Metal Recycling Facility

To: Rick Knowland
Barbara Barhydt
From: David Margolis-Pineo
Re: Polarized New England Company LLC
Changes to Approved Site Plan

Re: PNE Scrap Facility – Changes to Approved Site Plan

TO: Rich Carmosino
FROM: Neil J. Rapoza, PE
SUBJECT: Filter bench modification
DATE: 24 AUGUST 2011
REVISED 25 AUGUST 2011
PROJECT: 06-769.00 PROLERIZED NEW ENGLAND –
 RIVERSIDE STREET, PORTLAND, ME

POND 23 OUTLET – CONTROL STRUCTURE
NOT TO SCALE

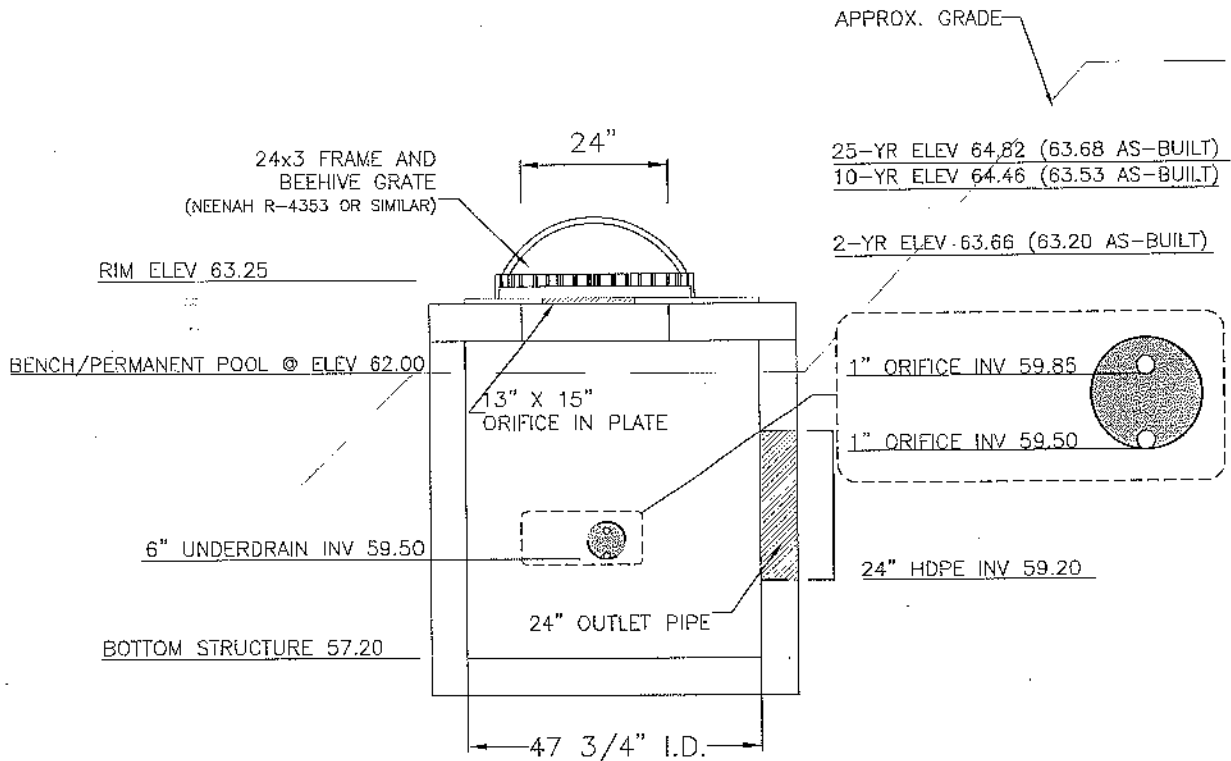
This memo has been prepared to address a proposed modification to the filter bench at the existing wet pond at the project facility. The material surrounding the 6" underdrain is to be removed and replaced with the more porous underdrain backfill material (MEDOT 703.22 Type C) to prevent premature clogging above the drain. Currently, the filter is blocked easily and stormwater exits through the overflow structure. The installation of the new material will maintain a functioning underdrain outlet over time.

As shown in the table, results of the analysis indicated that the installation of the proposed flow control cap will have an insignificant effect on the flows from the pond or the elevation of the pond itself.
